**MOORE PUBLIC SCHOOLS -
SOUTHGATE ELEMENTARY SCHOOL –
KITCHEN UPGRADES AND ADDITION**
Moore Public Schools - Moore, Oklahoma
AGP - Moore, Oklahoma

CONSTRUCTION BULLETIN NO. 1
September 8, 2026

1. SHEET C300 – GRADING PLAN – FIRE LANE UPDATE.
2. MEP ITEMS ADDRESSED FOR CITY OF MOORE PLAN REVIEW.
3. MEP COVER SHEET FOR CONSTRUCTION BULLETIN NO. 1.
4. SHEET P101 – REVISED PLUMBING PLAN, DETAIL #1.
5. SHEET E101 – REVISED ELECTRICAL LIGHTING PLAN, DETAIL #1.

C300

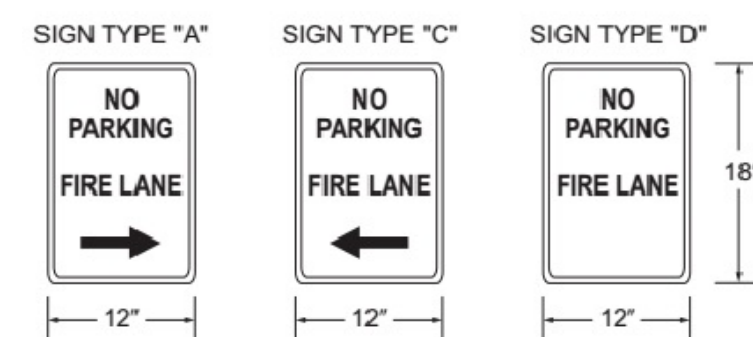
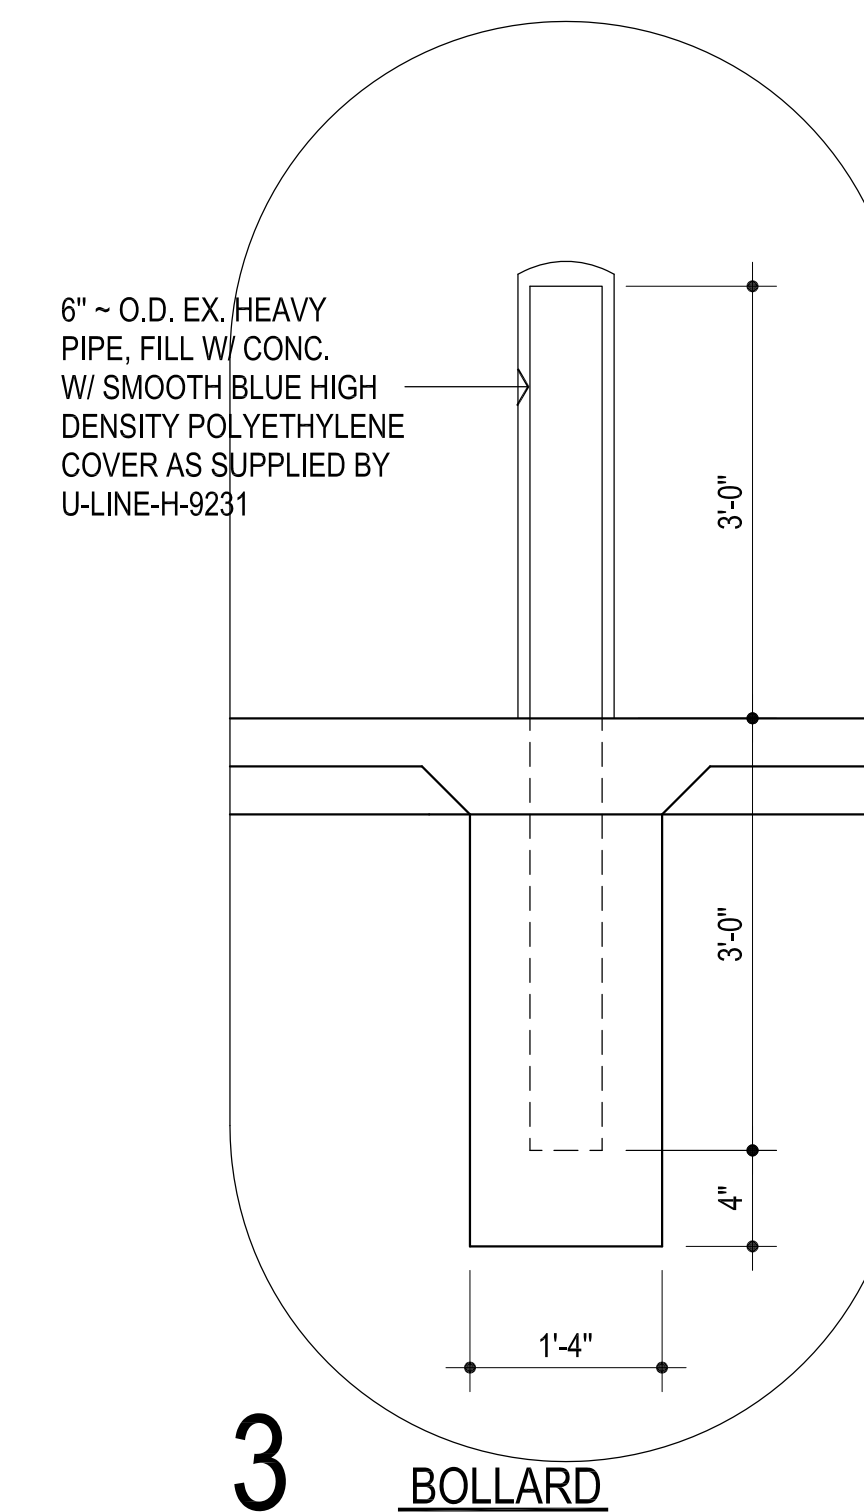
1. XXXXXXXXXX INDICATES "FIRE LANE NO PARKING" PROVIDE MARKINGS AT 50'-0" MAX. FIRE LANE TO BE 26'-0" MIN. WIDTH.

PROVIDE NEW BOLLARD
AS PER 2C300 - 7 TOTAL

1 PLUMBING PLAN
Scale: 1/4" = 1'-0"

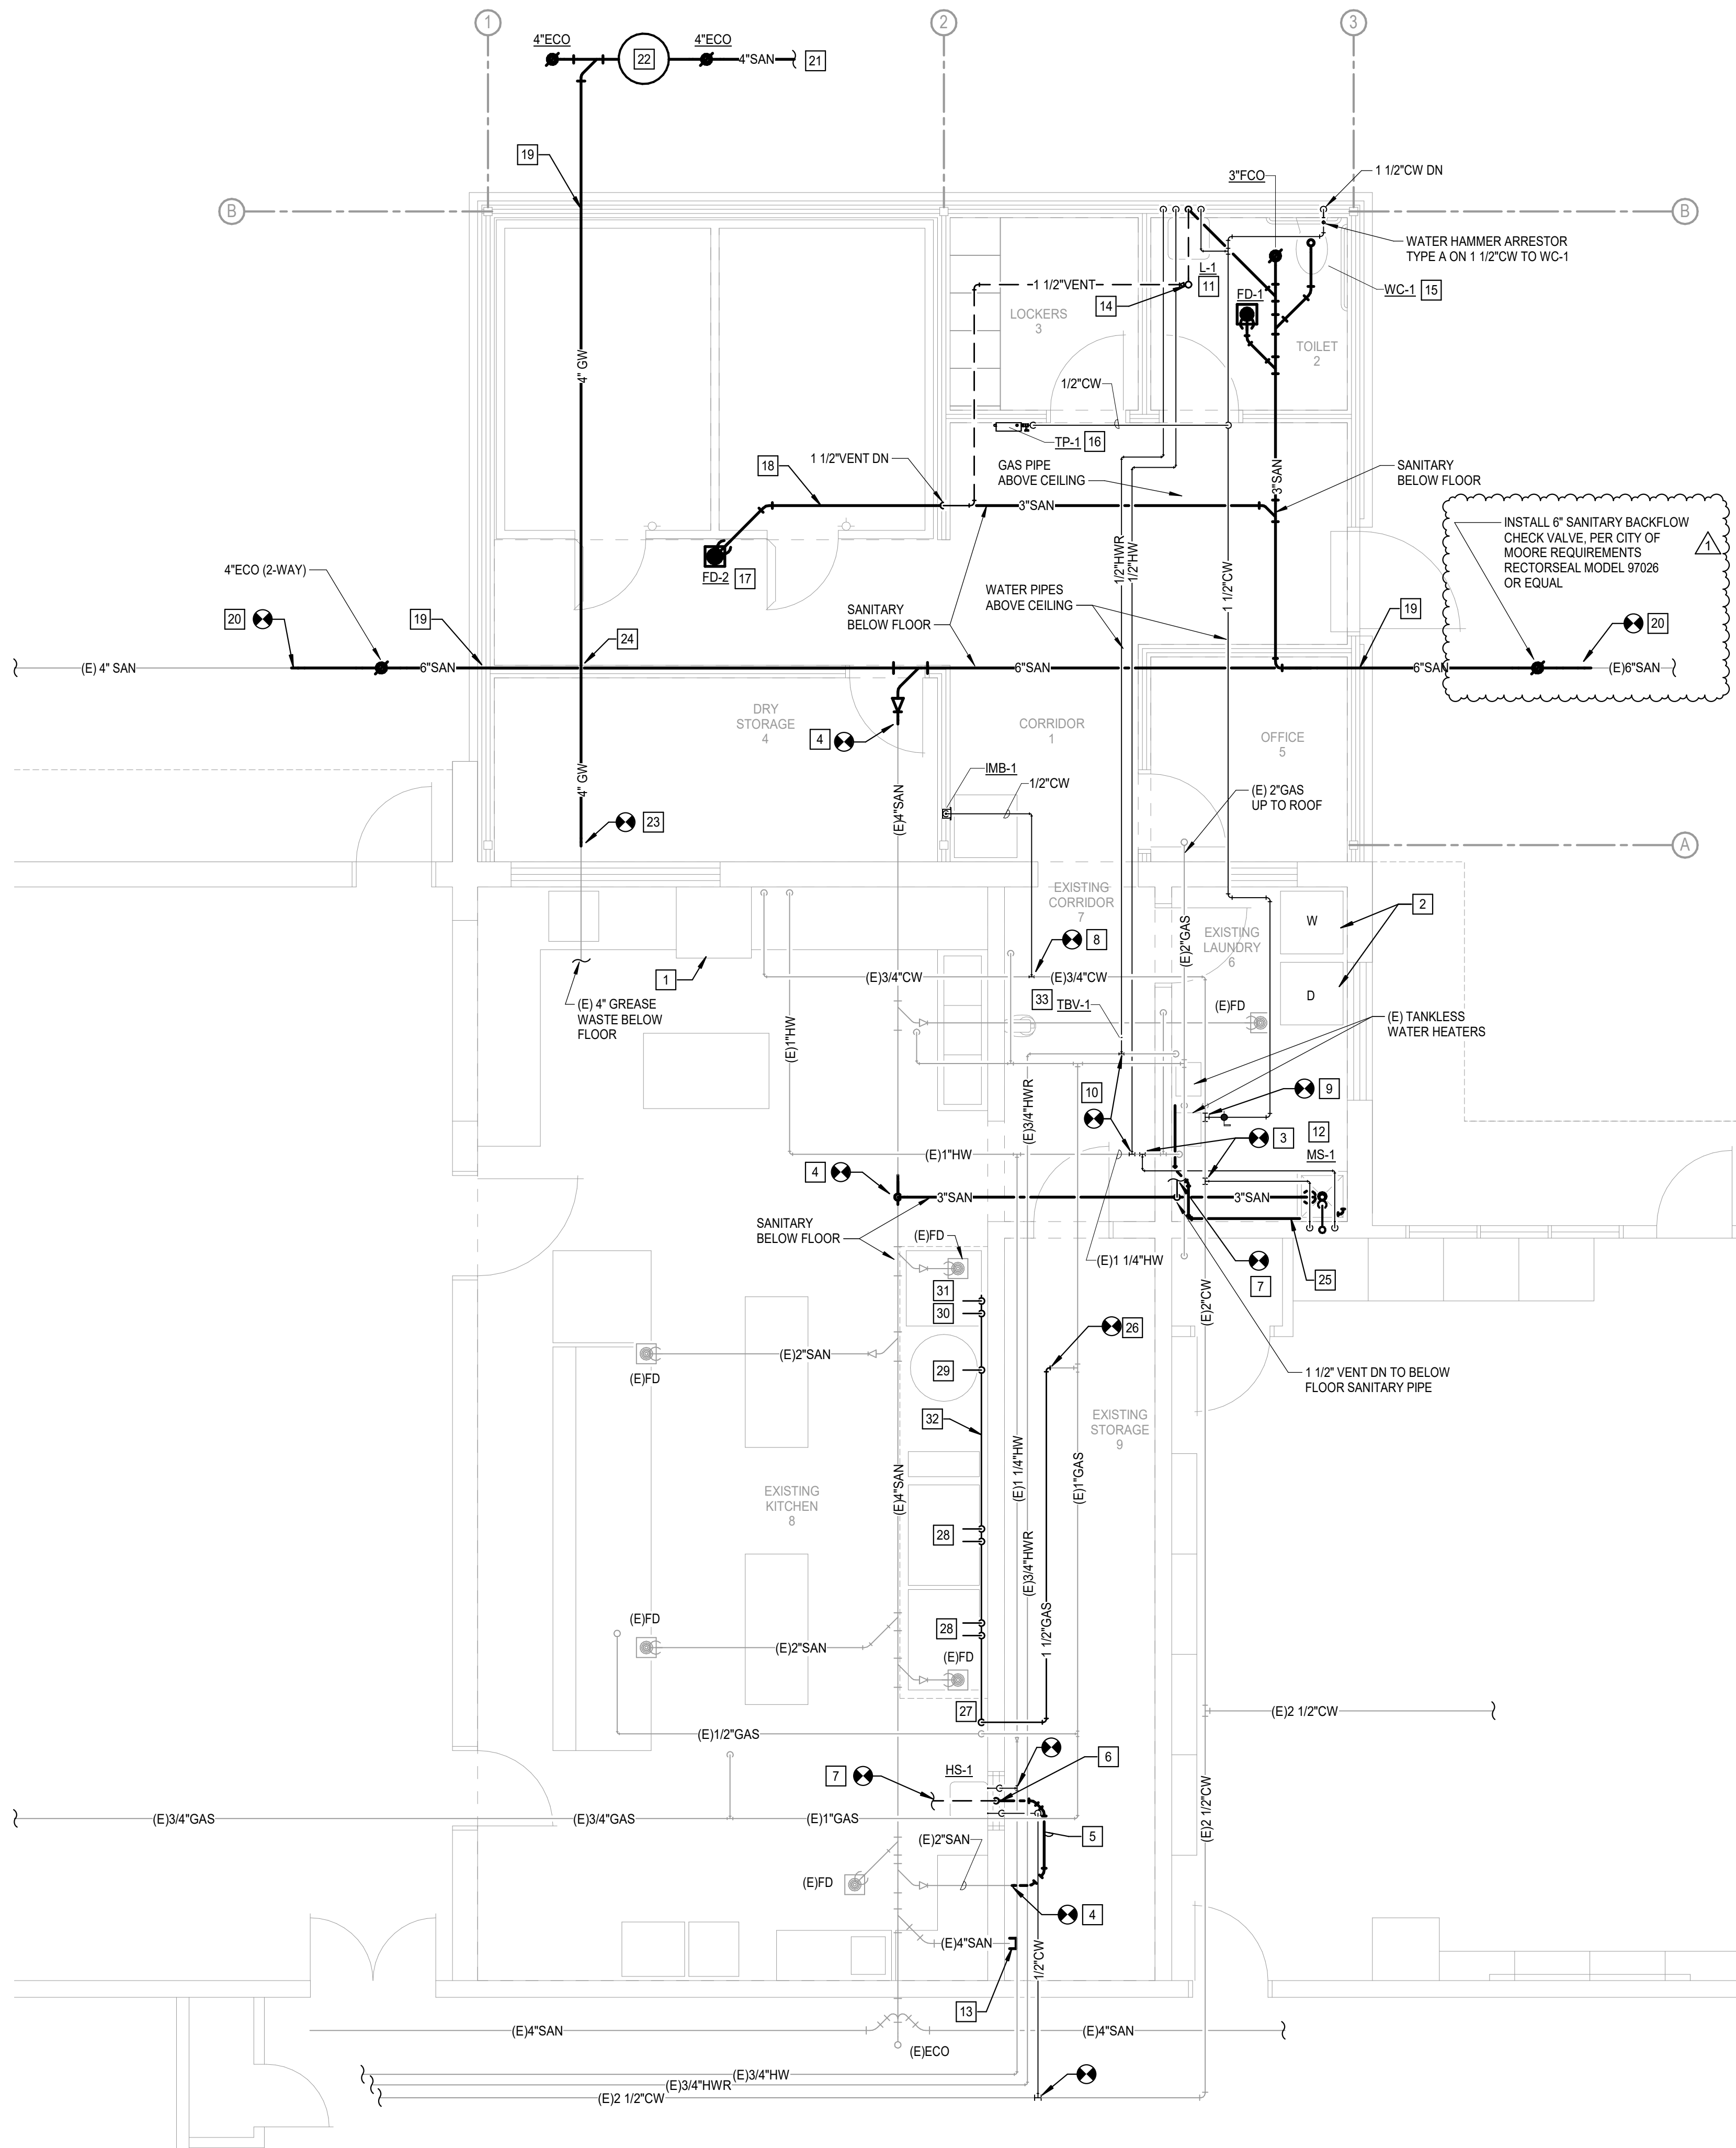
Item No.	Description	Attachment
1	Refer to clouds and deltas for changes on plans.	P101
2	Refer to clouds and deltas for changes on plans.	E101
